Docket Item #9
BAR CASE #2006-00170

BAR Meeting
September 20, 2006

ISSUE: Addition and alterations

APPLICANT: Roberts Memorial United Methodist Church by Moore Architects

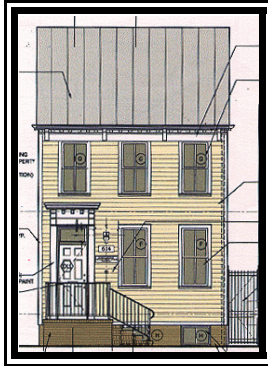
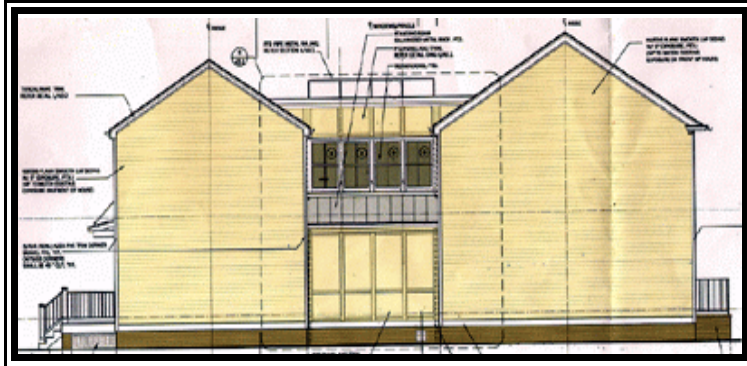
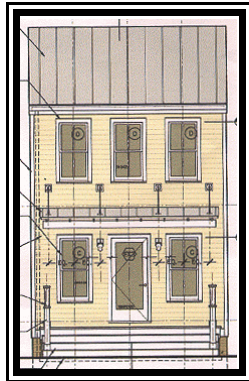
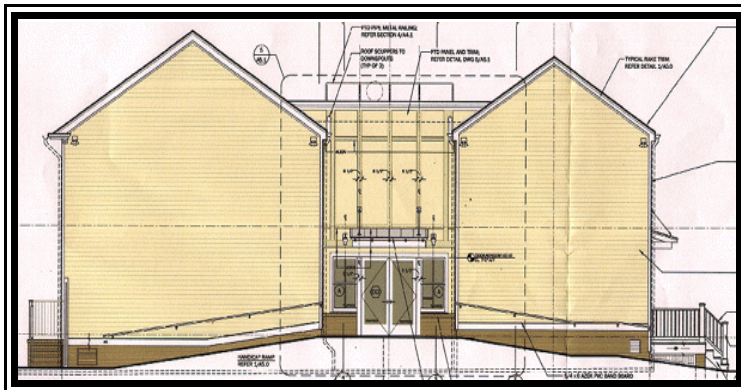
Staff has no objection to the use of Azek panels which help to create a differentiation between the new sections and the historic structure.

The proposed use of HardiPlank as replacement siding on the historic structure is contrary to the guidelines established by the Board for the use of fiber cement siding. Staff recommends that the existing vinyl siding on the historic structure be removed to determine if the existing wood siding can be rehabilitated. In the case that it is so deteriorated that it cannot be re-used then staff recommends the use of new wood siding to match in profile and exposure the existing wood siding.

1. That the existing vinyl siding on the historic structure be removed to determine if the existing wood siding can be rehabilitated. In the case that it is so deteriorated that it cannot be re-used then staff recommends the use of new wood siding to match in profile and exposure the existing wood siding;
